# Access Compliance Report

## Public Rights-of-Way

### (Curb Ramps)

Intersection ID: 4486	Main Street: FRANK_VANCE_RD	Cross Street: KARA_DR	Location:	N
ADA ID: 5DA7201A0F3A	Ramp Type: Perp	Initial Pass/Fail: Pass	Overall Compliance: No	Severity Score: 0
Codes/Mitigation Info/Possible Solution		Field Measurements/Component Compliance

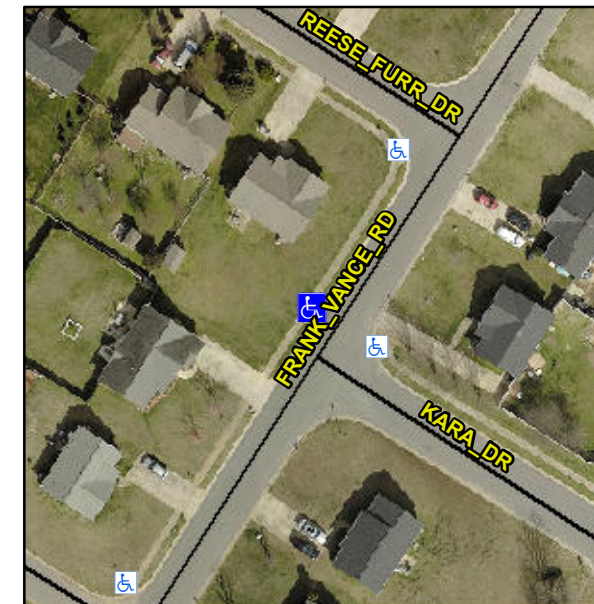
**Not Found, R304.2.1, R305.2**

Compliance	Description	Data	Compliance	Description	Data
N/A	Ramp Length (in)	47.5	Yes	Ramp Slope (%)	5.2
Yes	Ramp Width (in)	48.0	Yes	Ramp XSlope (%)	1.8
N/A	Flare Type LT	Sloped	N/A	Flare Type RT	N/A
N/A	Flare Slope LT (%)	3.9	Yes	Flare Slope RT (%)	6.2
N/A	Flare Traversable LT?	Yes	N/A	Flare Traversable RT?	Yes
No	Landing Length (in)	47.5	Yes	DWS Provided?	Yes
Yes	Landing Width (in)	48.0	Yes	DWS Contrast?	Yes
Yes	Landing Slope (%)	1.8	Yes	DWS Length (in)	24.0
Yes	Landing X Slope (%)	0.7	Yes	DWS Full Width?	Yes
N/A	Landing Curb? (Y/N)	No	No	DWS Offset (in)	6.5
N/A	Shared Landing?	No			
Yes	Gutter Ponding?	No	Yes	Gutter Slope (%)	2.1
Yes	Gutter Lip Ht (in)	0.0	Yes	Gutter X Slope (%)	0.7
N/A	Painted X Walk1?	No	N/A	Painted X Walk2?	N/A
	X Walk 1 Direction	To SW		X Walk 2 Direction	N/A
N/A	X Walk 1 Width (in)	N/A	N/A	X Walk 2 Width (in)	N/A
	X Walk 1 Slope (%)	2.2		X Walk 2 Slope (%)	N/A
	X Walk 1 X Slope (%)	0.4		X Walk 2 X Slope (%)	N/A

**Remove & Replace Entire Ramp.**
